SUBJECT: Addendum No. 4

REFERENCE: Invitation To Bid (ITB) for HOU Restroom Renovation Phase 2; Solicitation No. HHG-HRESTR-2022-019; Project No. PN209A

NARRATIVE ADDENDUM NO. 4

SHEET No. A-422 SCALE: As indicated

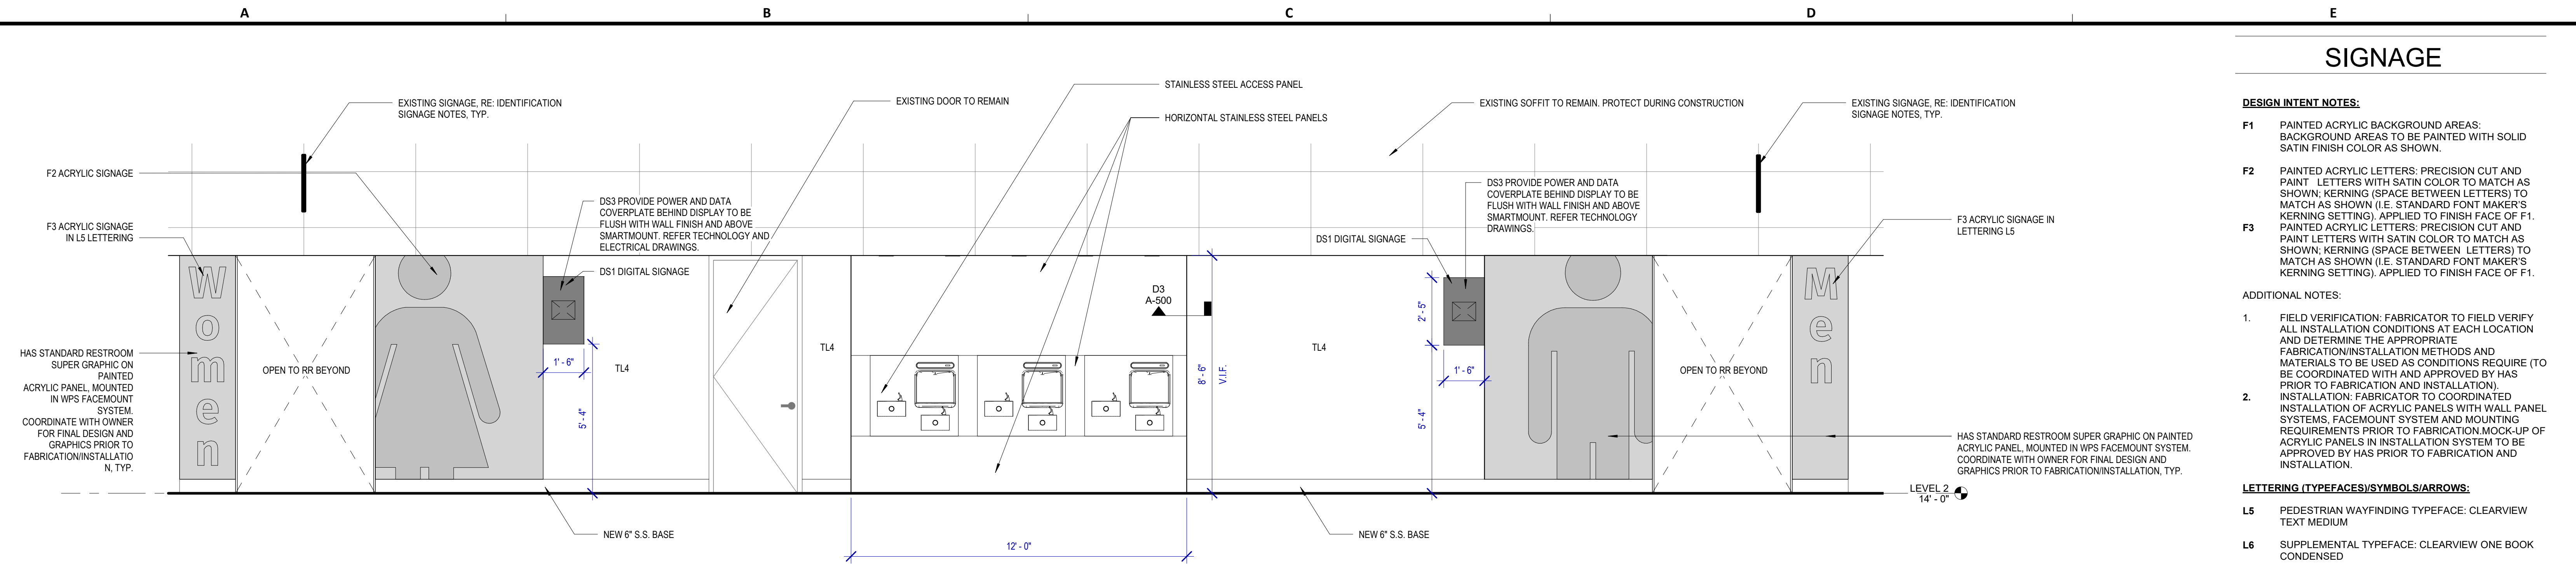
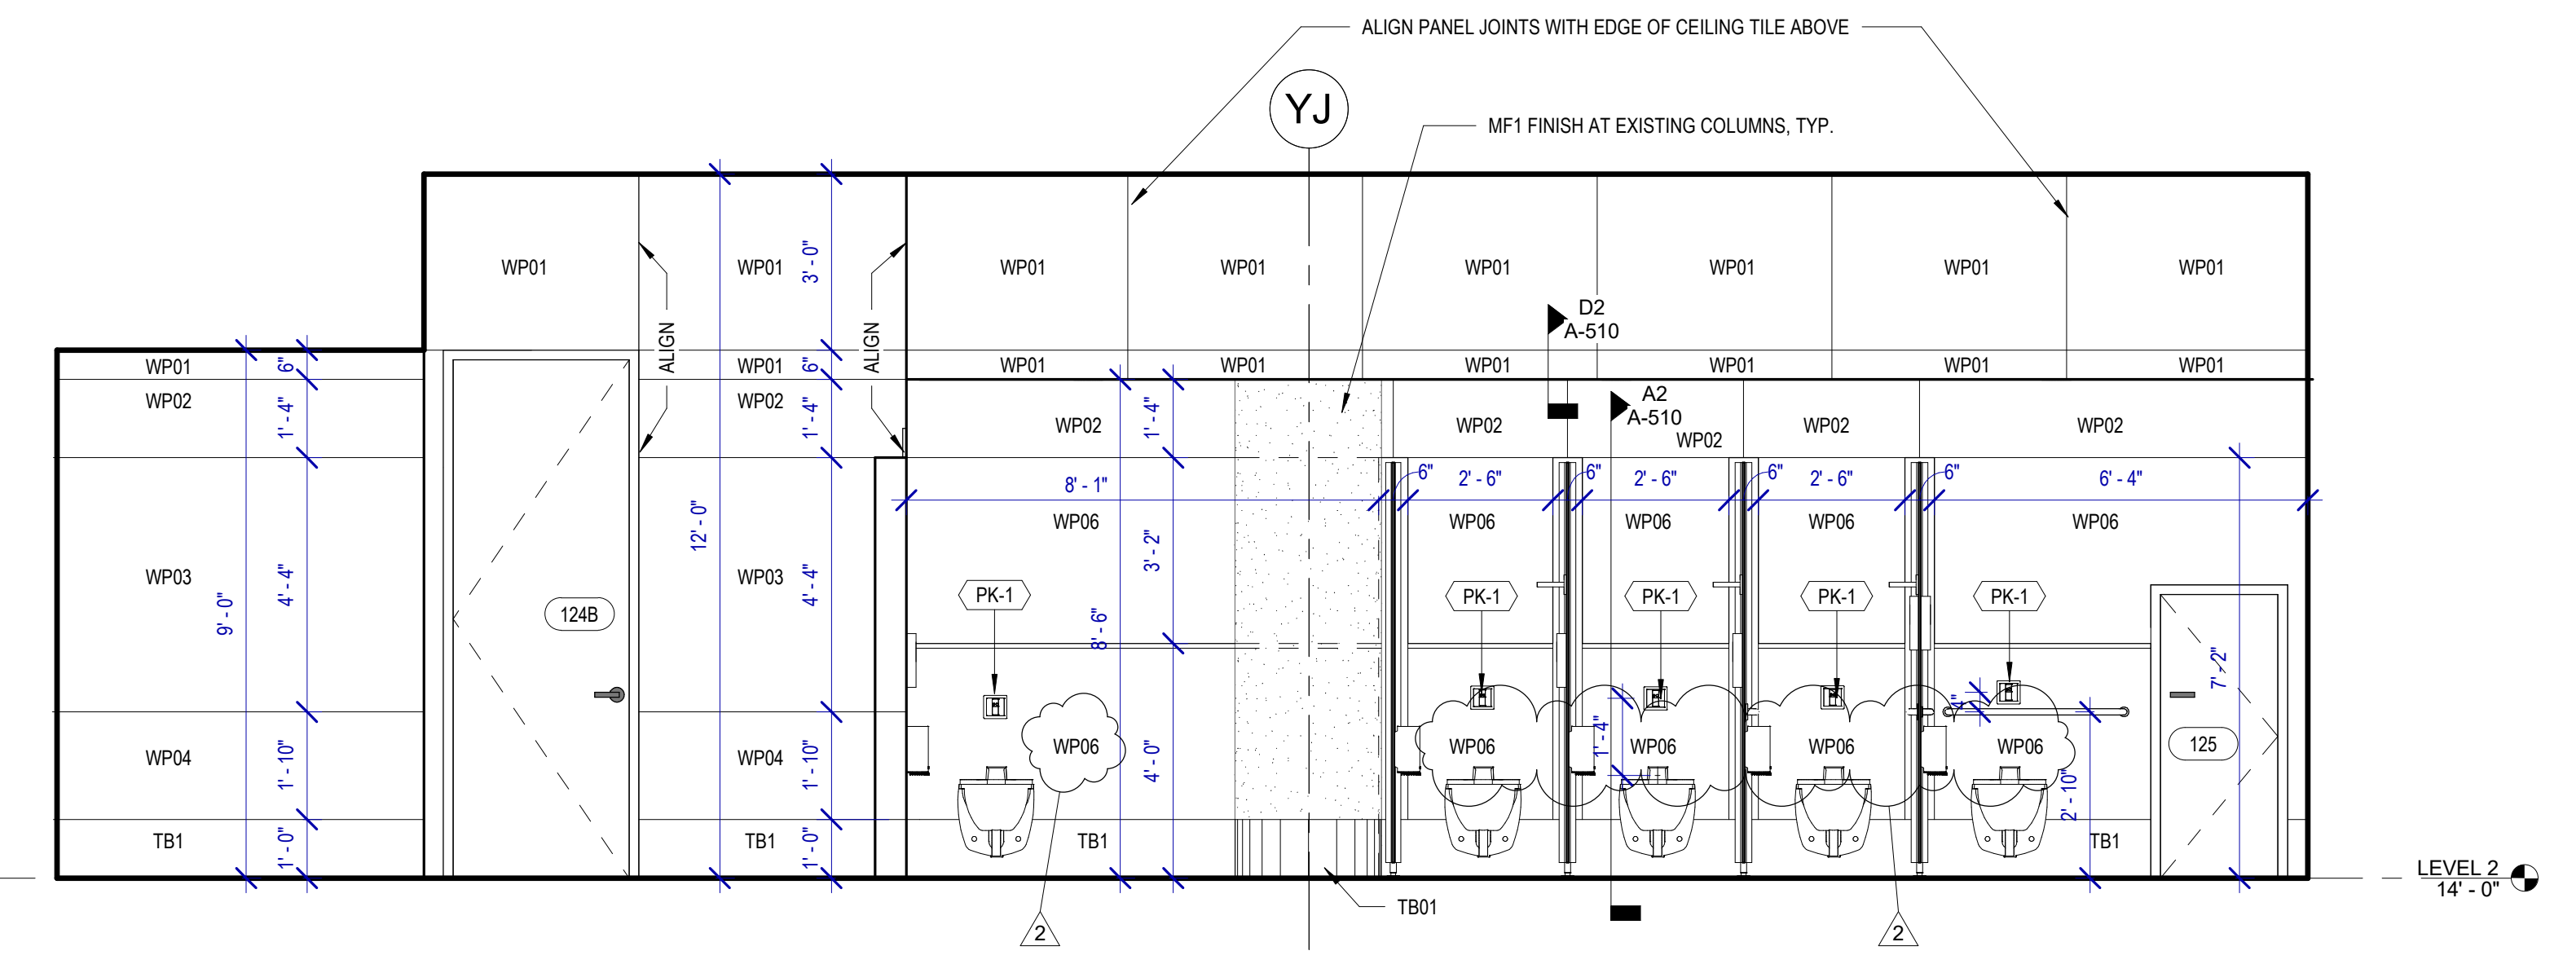
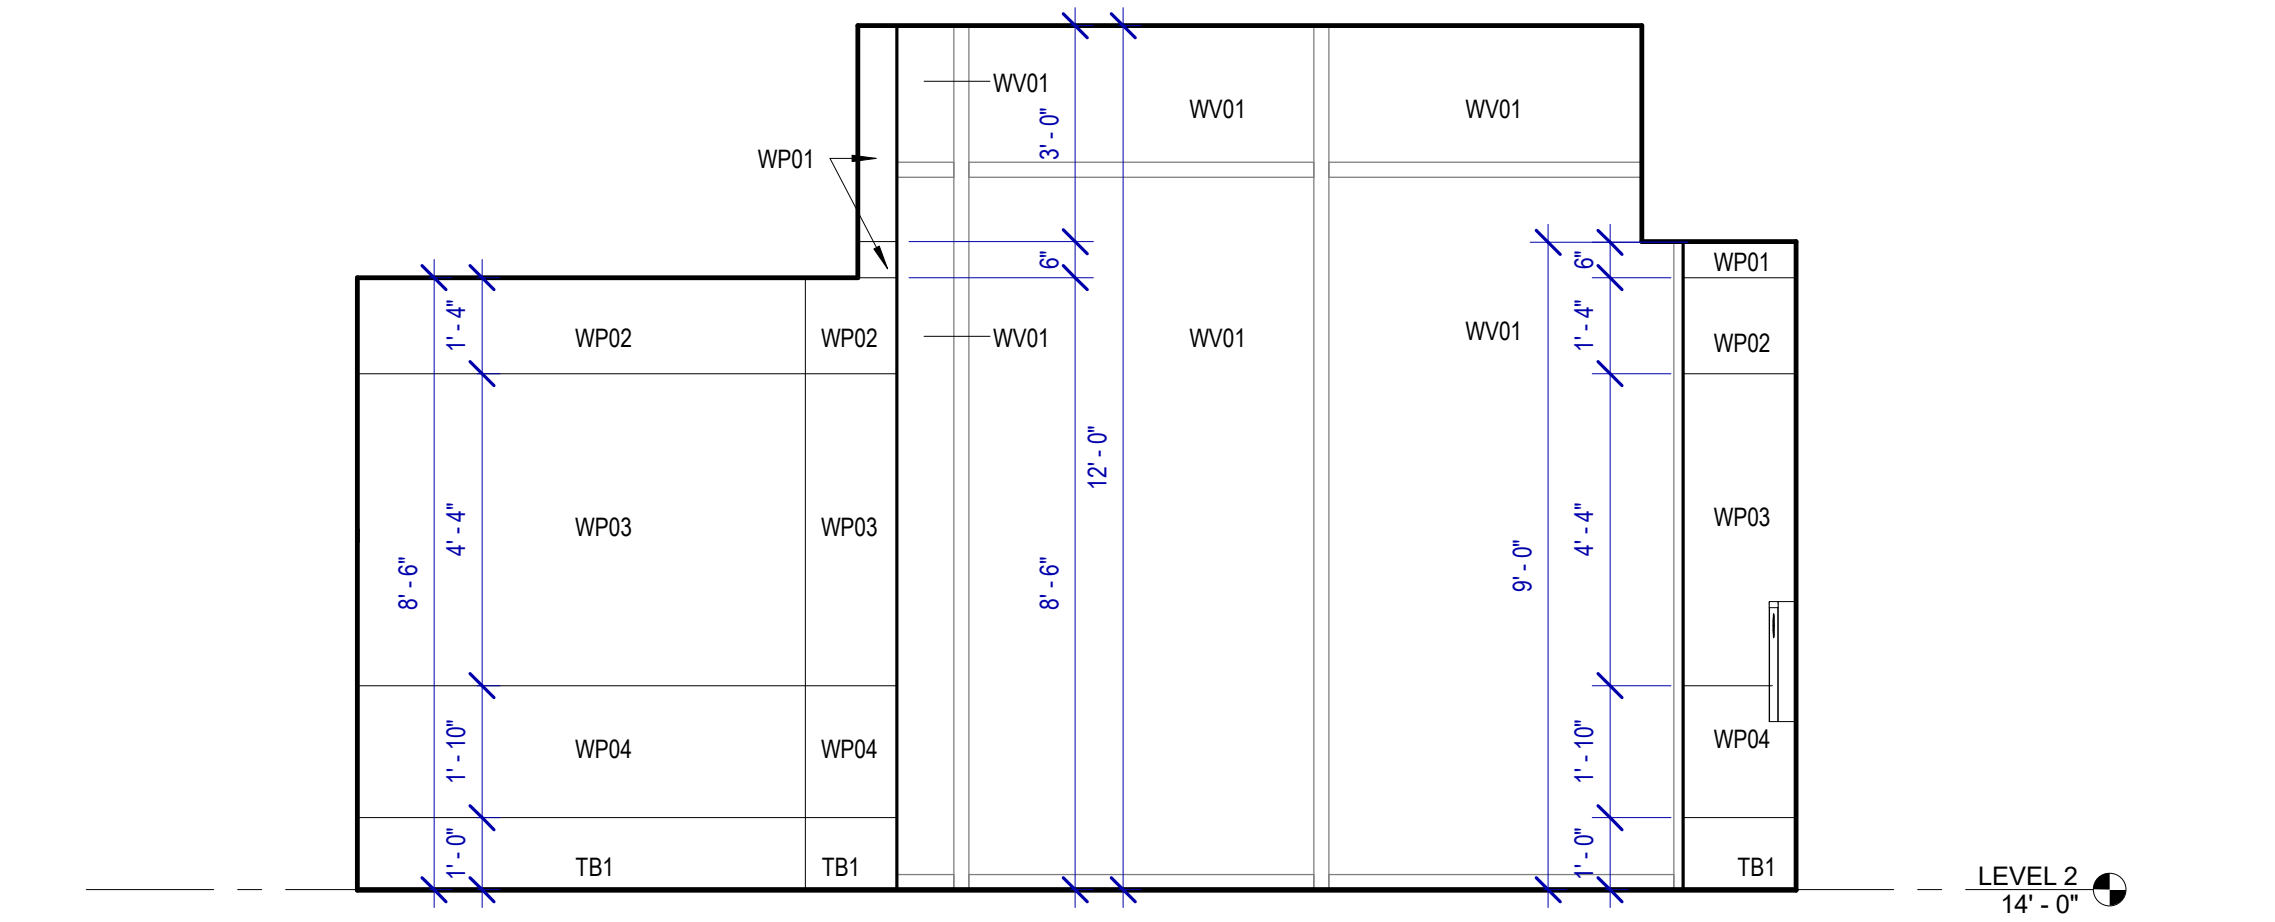
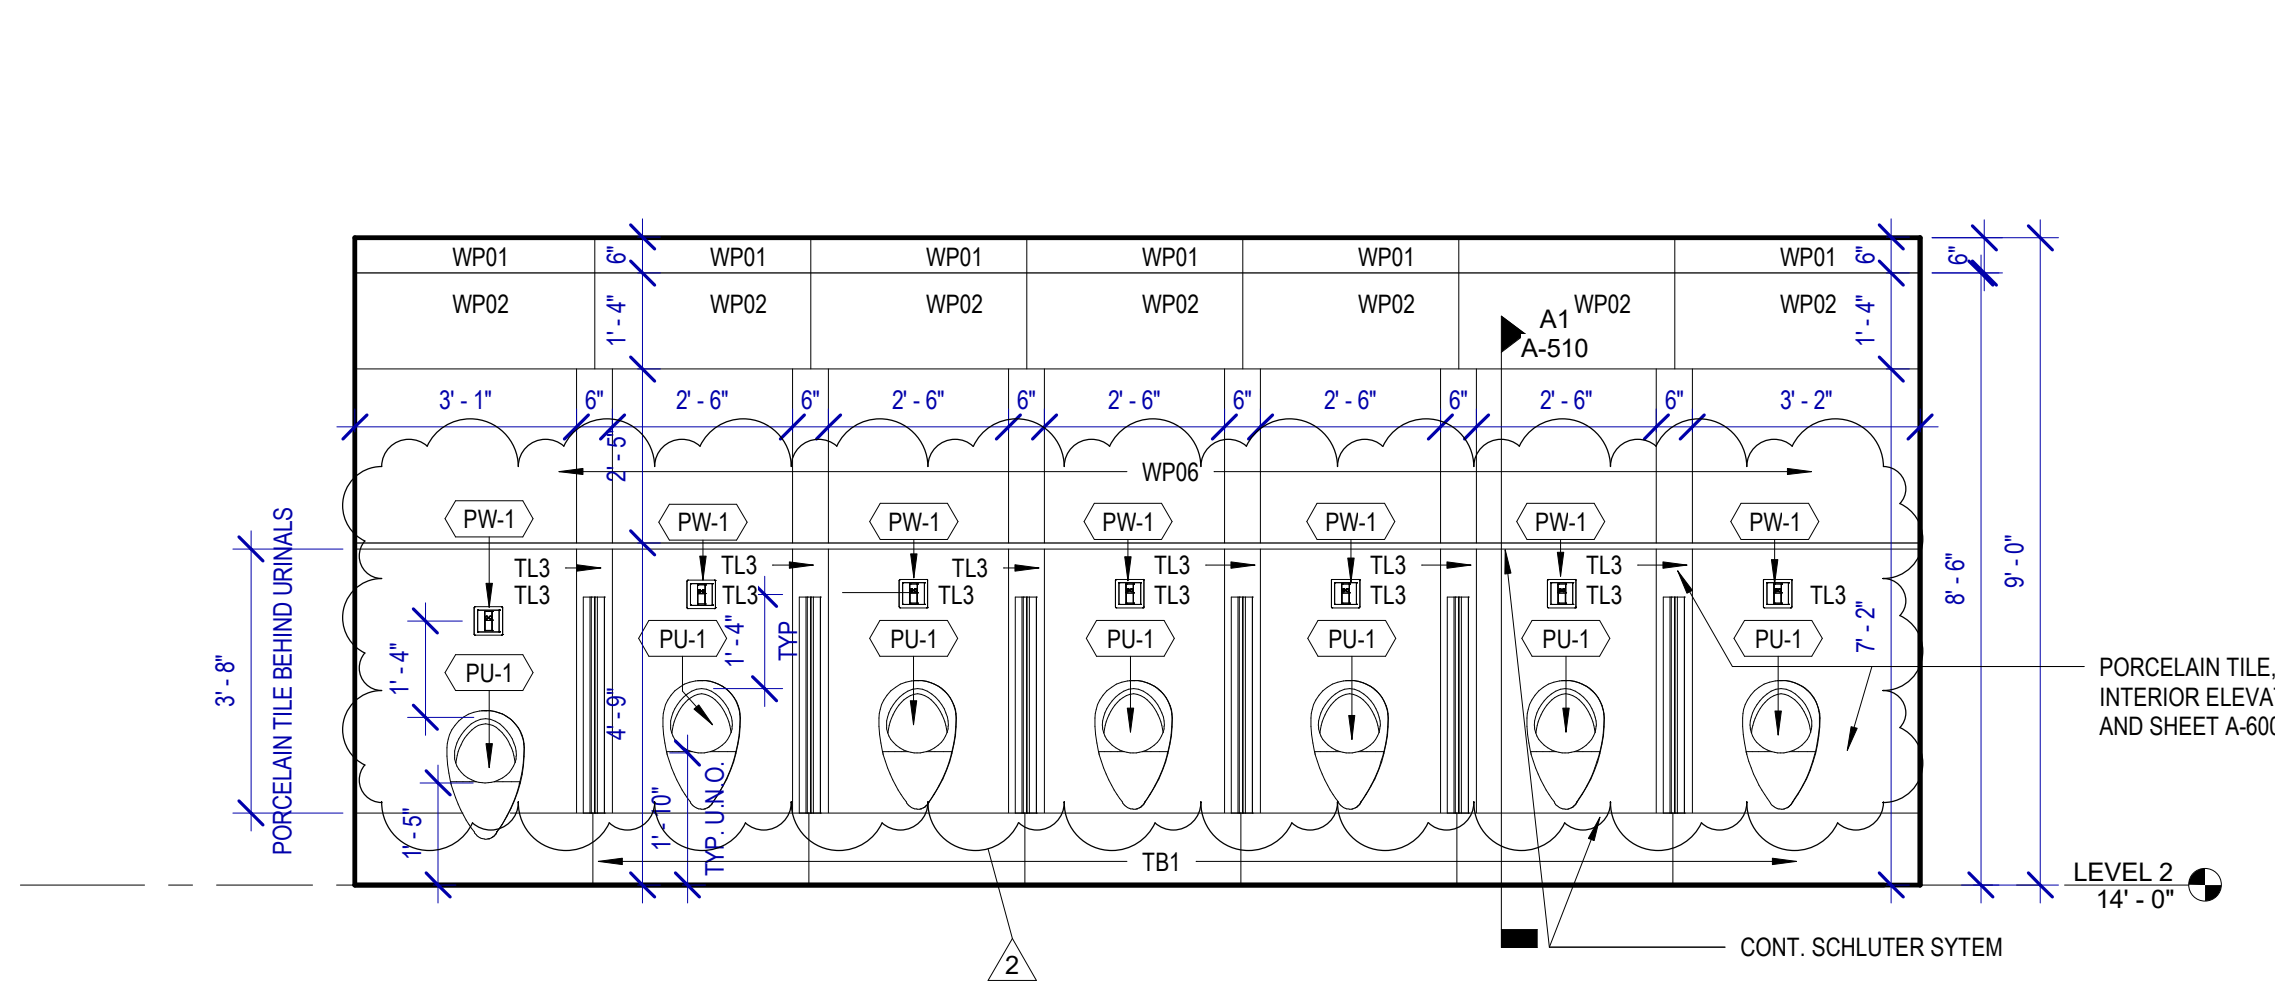
A-422	<ul style="list-style-type: none"> a. Toilet Accessories legend and Plumbing fixtures legend updated: <ul style="list-style-type: none"> 1. Not used items PC4, PC5 and PS1 were deleted. 2. Lovair accessories were renamed to read Splash Lab USA. ID information updated for PF-1, PF2, PO-1, PL-1, and PL-2. 3. PM-1 Carvart Frameless LED Mirror Added. 4. TF-1 model # revised to read: 461202. b. Detail B2 Revised. <ul style="list-style-type: none"> 1. Back Splash added 2. Mirror dimensions added. 3. Symbol PM-2 added. 4. Trespa panels symbols revised for clarification. c. Detail B1 and A3: Trespa panel symbol WP05 added for clarification
	A-423	<ul style="list-style-type: none"> a. Toilet Accessories legend and Plumbing fixtures legend updated: <ul style="list-style-type: none"> 1. Not used items PC4, PC5 and PS1 were deleted. 2. Lovair accessories were renamed to read Splash Lab USA. ID information updated for PF-1, PF2, PO-1, PL-1, and PL-2. 3. PM-1 Carvart Frameless LED Mirror Added. 4. TF-1 model # revised to read: 461202. b. Detail C2 Revised. <ul style="list-style-type: none"> 1. Back Splash added 2. Mirror dimensions added. 3. Mirror Symbol revised to read PM-2. c. Detail A3: Trespa panel symbol WP06 added for clarification d. Detail B1: Sanitizing Station revised to add symbol TF-1 e. Detail A1: TL3 Symbol added.
